Access Compliance Report

Public Rights-of-Way

(Curb Ramps)

Intersection ID: 27595	Main Street: BALLANTYNE COMMONS PY	Cross Street: BALLANTYNE MEADOWS DR	Location: S
ADA ID: 0BCD60C35264	Ramp Type: Perp	Initial Pass/Fail: Fail	Overall Compliance: No
Severity Score: 10			
Codes/Mitigation Info/Possible Solution		Field Measurements/Component Compliance

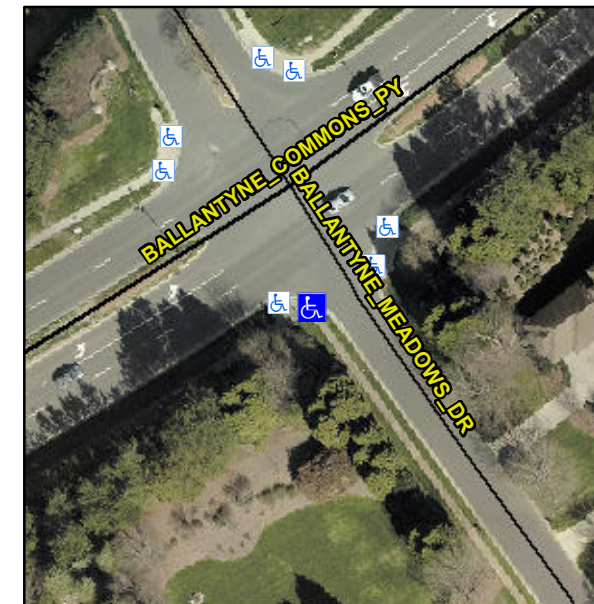
Not Found, R304.5.1, R304.5.3

Compliance	Description	Data	Compliance	Description	Data
N/A	Ramp Length (in)	84.0	Yes	Ramp Slope (%)	8.1
No	Ramp Width (in)	44.0	No	Ramp XSlope (%)	2.3
N/A	Flare Type LT	N/A	N/A	Flare Type RT	N/A
N/A	Flare Slope LT (%)	N/A	N/A	Flare Slope RT (%)	N/A
N/A	Flare Traversable LT?	N/A	N/A	Flare Traversable RT?	N/A
N/A	Landing Length (in)	N/A	N/A	DWS Provided?	N/A
N/A	Landing Width (in)	N/A	N/A	DWS Contrast?	N/A
N/A	Landing Slope (%)	N/A	N/A	DWS Length (in)	N/A
N/A	Landing X Slope (%)	N/A	N/A	DWS Full Width?	N/A
N/A	Landing Curb? (Y/N)	N/A	N/A	DWS Offset (in)	N/A
N/A	Shared Landing?	N/A			
N/A	Gutter Ponding?	N/A	N/A	Gutter Slope (%)	N/A
N/A	Gutter Lip Ht (in)	N/A	N/A	Gutter X Slope (%)	N/A
N/A	Painted X Walk1?	No	N/A	Painted X Walk2?	N/A
	X Walk 1 Direction	To NE		X Walk 2 Direction	N/A
N/A	X Walk 1 Width (in)	N/A	N/A	X Walk 2 Width (in)	N/A
	X Walk 1 Slope (%)	2.8		X Walk 2 Slope (%)	N/A
	X Walk 1 X Slope (%)	0.9		X Walk 2 X Slope (%)	N/A

Remove & Replace Entire Ramp.
